### SB-65 2022 & 2023 Allegro Open Road 8K Hollow Leg Jack Replacement

# JACK INSPECTION, REMOVAL AND REPLACEMENT (IF NEEDED) FOR 8K JACKS ON MOTORIZED UNITS

TSB Number:	85-001-2022		
Product:	8K Leveling Jacks		
Date:	November 18, 2022	Labor Rate:	0.3 Hour Inspection per Unit
			1.0 Hour Replacement per Jack

**Figure 1**

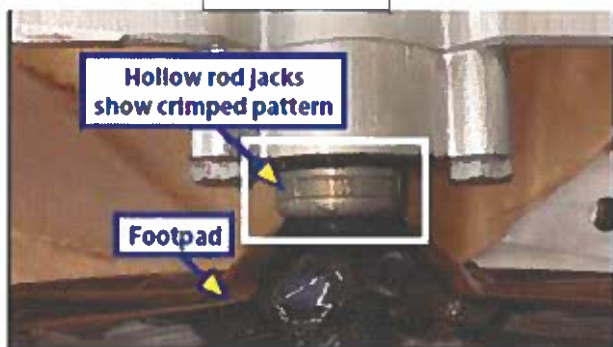
Owners may be able to determine if the front jacks installed on their unit are involved and need to be replaced. The pictures below show that the 8k hollow rod jacks that need to be replaced have a crimped pattern directly above the footpad (Figure 1). The 8k solid rod jacks that do not need to be replaced are not crimped directly above the footpad (Figure 2). If the jacks installed on your unit are not involved, you can email that information to [recalls@tiffinmotorhomes.com](mailto:recalls@tiffinmotorhomes.com) along with your VIN number to close the service bulletin for your coach.

Fig. 5

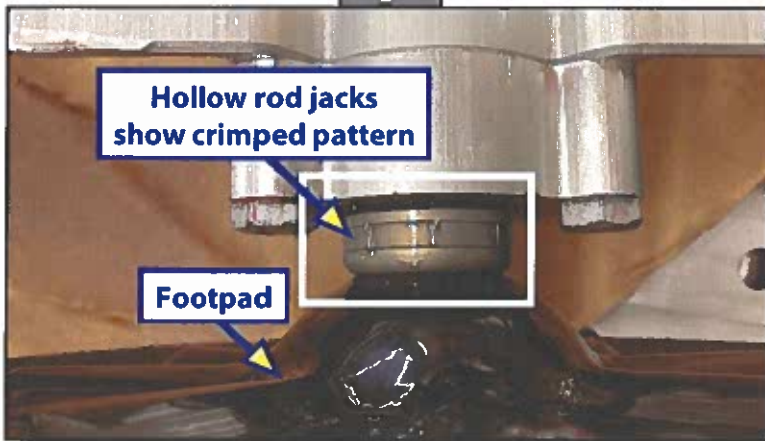
3. If the unit has 8K Gen I jacks, the ONLY Gen I jacks involved in this TSB document have a crimped pattern which indicates a hollow rod (Fig. 5), visible even when the jack is retracted. Solid rod jacks do not have the crimped pattern (Fig. 6), showing a solid smooth edge around the machined end.

**NOTE:** If it is determined that the unit has Gen I jacks with a solid rod, then no replacement per this TSB is required.

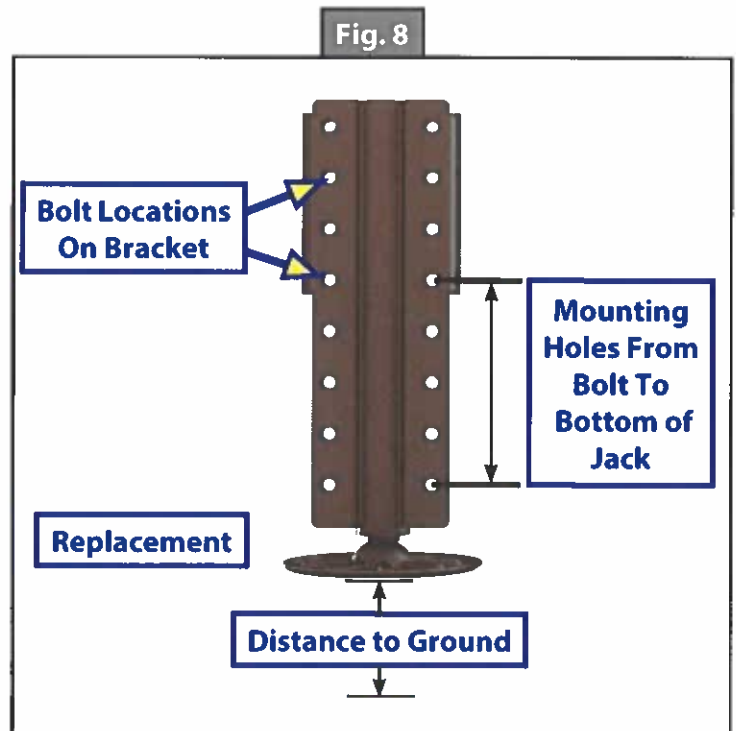
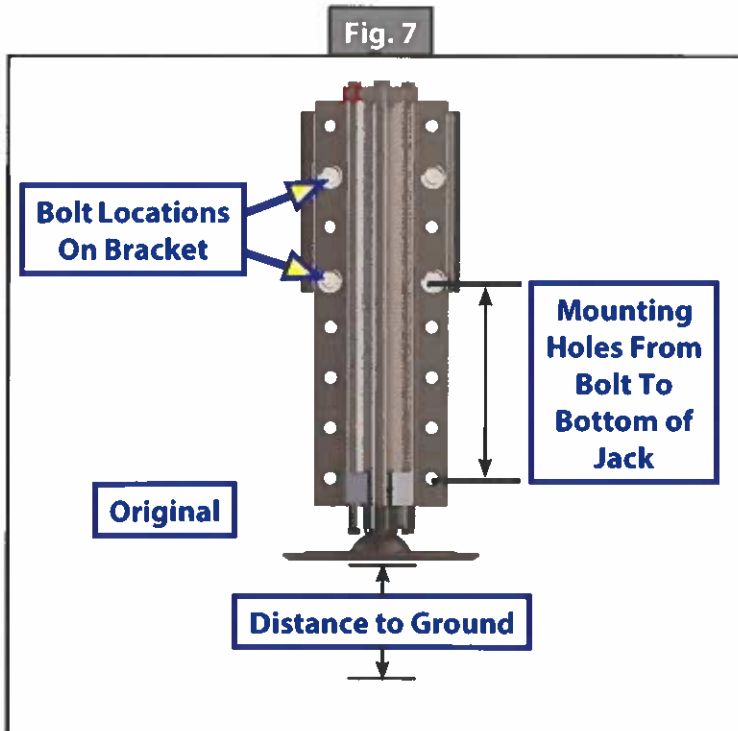
1. Before removing the original jack, note the location of the mounting holes on the jack and the mounting bracket (Fig. 7 or Fig. 8).

2. Measure the distance from the ground to the footpad of the retracted jack (Fig. 5 or Fig. 6).
3. When reinstalling jacks, match the number of mounting holes from the first bolt to the bottom of the jack (Fig. 7 or Fig. 8).
4. When reinstalling jacks, be sure to install bolts in the same location based on the number of mounting holes to the bottom of jack.
5. Once installation of the Gen II jack has been completed, measure the distance from the footpad to the ground to verify installation is correct.

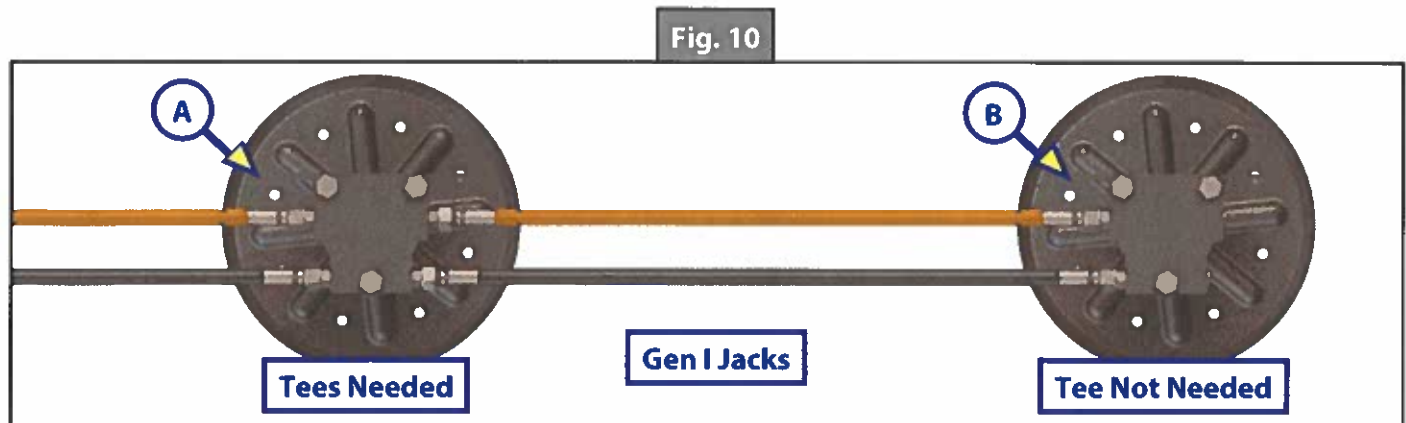
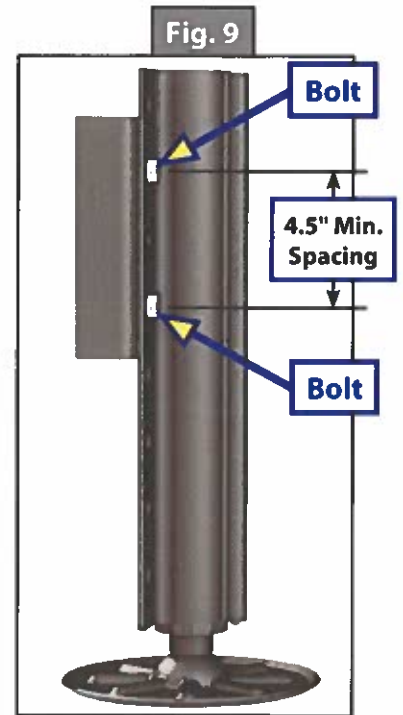
1. Remove hoses from the 8K jacks on the unit.
2. Follow procedures outlined in the Replacement Jack Location section, and then unbolt and remove existing leveling jacks (Fig. 7).
3. Match the number of mounting holes from the first bolt to the bottom of the jack and then bolt the new Gen II jacks (Fig. 8) to the mounting brackets.
  - A. Upper and lowermost bolts are vertically spaced with a minimum of two-hole patterns spaced 4.5" apart (Fig. 9) and tightened. Torque to 90 ft-lbs for a lubricated bolt or torque to 120 ft-lbs for dry bolt. A spacing of three-hole patterns (6.75") is recommended where possible.
4. Measure the distance from the footpad to the ground to verify installation is correct.
5. Connect the hoses to the new 8K Gen II jacks.

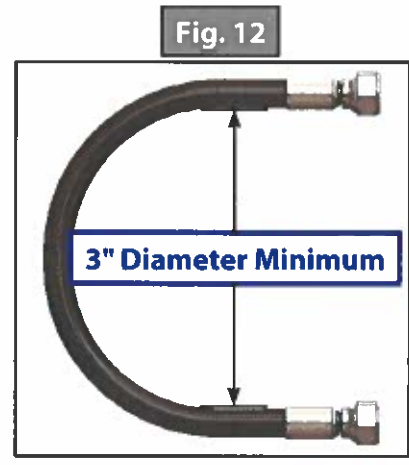
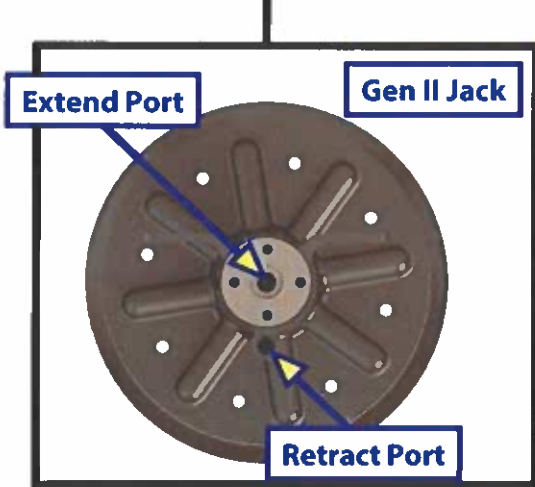
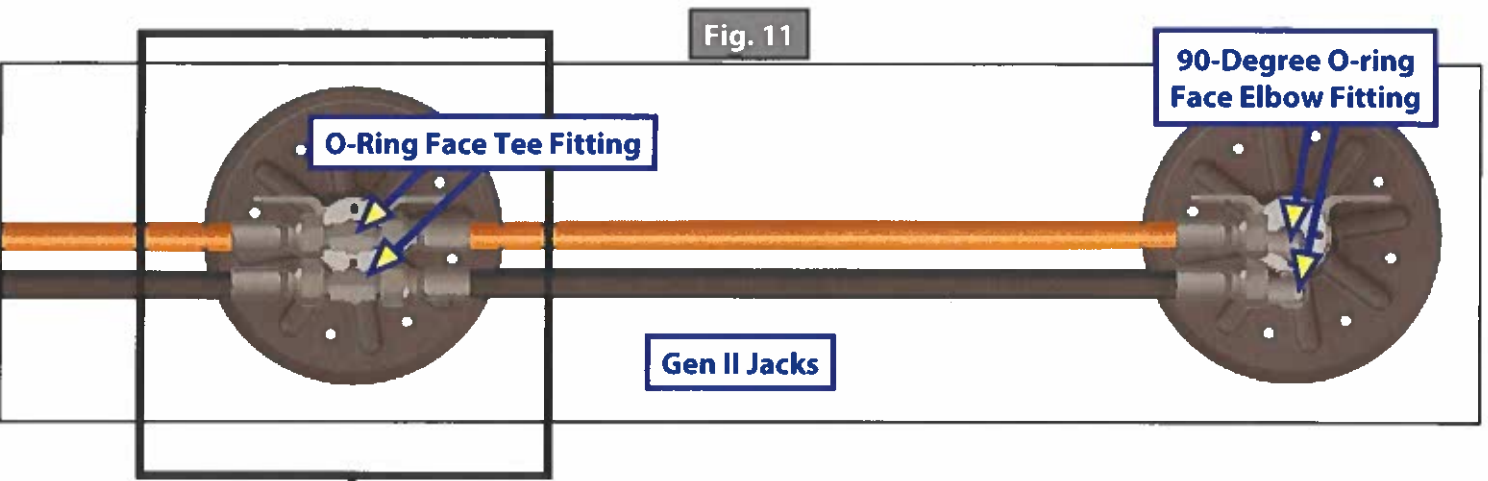
- A. If the Gen I jack has two orange extend hoses and two black retract hoses (Fig. 10A), an O-ring face tee fitting (Fig.11) must be used to connect the hoses to the single extend and retract hoses on the Gen II jack (Fig. 11).
- B. If the Gen I jack has only one orange extend hose and one black retract hose (Fig. 10B), a 90-degree O-ring face elbow fitting (Fig. 11) will be needed to connect the single black and orange hoses to the Gen II jack (Fig. 11).

**NOTE:** If hoses need to be replaced, measure and make the hydraulic hoses. Always follow the manufacturer's specifications for the correct minimum bend radius throughout the entirety of the hose route. Use gauges to verify areas with questionably tight bends. Fitting orientation can be adjusted to achieve this in some applications. The correct bend radius is shown in Fig. 8.
